07-AFC-5

**RE: COMMENTS ON THE PRELIMINARY STAFF ASSESSMENT FOR THE
PROPOSED IVANPAH SOLAR ELECTRIC GENERATING SYSTEM
PROJECT (07-AFC-5)**

Draft Memo

To: Charles Hall, Pam Adams, Robert Tweedy, Teresa Arnold
 From: Robert Varani, Rylan Juran
 CC:
 Date: January 23, 2009
 Re: IVP Solar Electric Generating System Impacts

EXHIBIT 1

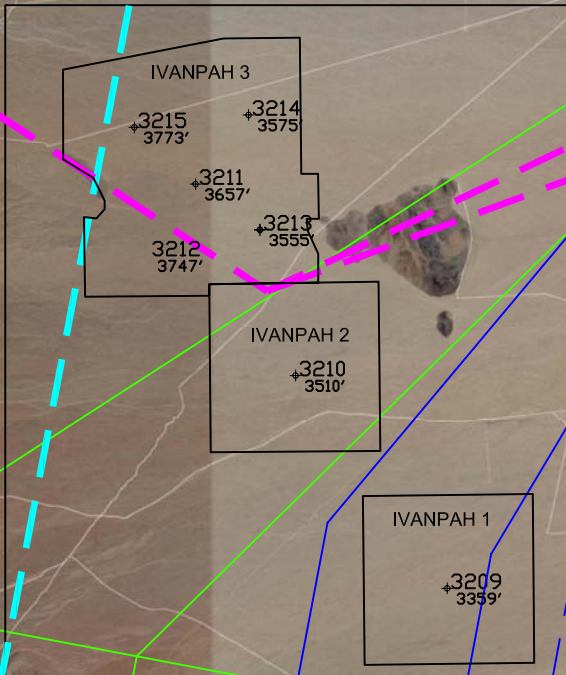
ASRC, under contract with the Clark County Department of Aviation has been asked to determine what, if any, impact the Ivanpah Solar Electric Generating System (ISEGS) proposed by BrightSource Energy will have on the Proposed Ivanpah airport. To complete this task, an analysis of the tower locations was conducted considering FAA design standards and criteria including, FAA Order JO 7110.65S *Air Traffic Control* and FAA Order JO 7400.2G *Procedures for Handling Airspace Matters*, 8260.3B *United States Standard for Instrument Procedures (TERPS)*, and 8260.44A *Civil Utilization of Area Navigation (RNAV) Departure Procedures*. Tower location data was obtained from seven FAA 7460 forms retrieved from the FAA. The only data supplied by BrightSource were the FAA 7460 numbers. ASRC was informed that there were originally 13 towers proposed, but that number has been changed to seven. The following table depicts the FAA study number, location, and height of each structure. **Exhibit 1** depicts the proposed solar towers in relation to the Ivanpah Airport.

FAA Part 77 surfaces provide a means for identifying obstacles to air navigation. Depending on which surface is penetrated, offending obstacles must be removed, altered, or lighted. It was found that none of the proposed solar towers will penetrate the Part 77 surfaces. In fact, the proposed towers do not lie beneath the Part 77 surfaces.

The ISEGS does not penetrate the 40:1 RNAV surface. In addition, terrain and ATC driven climb gradients are likely to be higher, and so the ISEGS is not a significant impact to RNAV route departures.

Glare from the heliostat mirrors could be a significant hazard to air navigation. The towers are located between approximately 2.3 and 4.6NM from the proposed runway centerline. Westbound RNAV Departures from Runways 18L and 18R fly directly over the ISEGS. Arrivals to Runways 36L and 36R may overfly or be directly pointed at the ISEGS while turning to make a final approach. **Exhibit 1** shows RNAV flight tracks and ILS obstacle clearance surfaces in relation to the ISEGS. The close proximity between the ISEGS and flight paths means it is highly likely that at some point the aircraft will be in line with reflective mirrors pointed at the receiver tower. Any "spillage" of the beam would then be focused directly on the aircraft. This glare could then potentially blind a pilot during this critical phase of flight. It is also likely that at some time, one or more of the heliostat mirrors will not be pointing at the receiver. This could be due to malfunction, cleaning, or scheduled maintenance, or by design to regulate the temperature of the receiver. There is a potential for the beam of light to be pointed not at the receiver tower, but directly into the flight path.
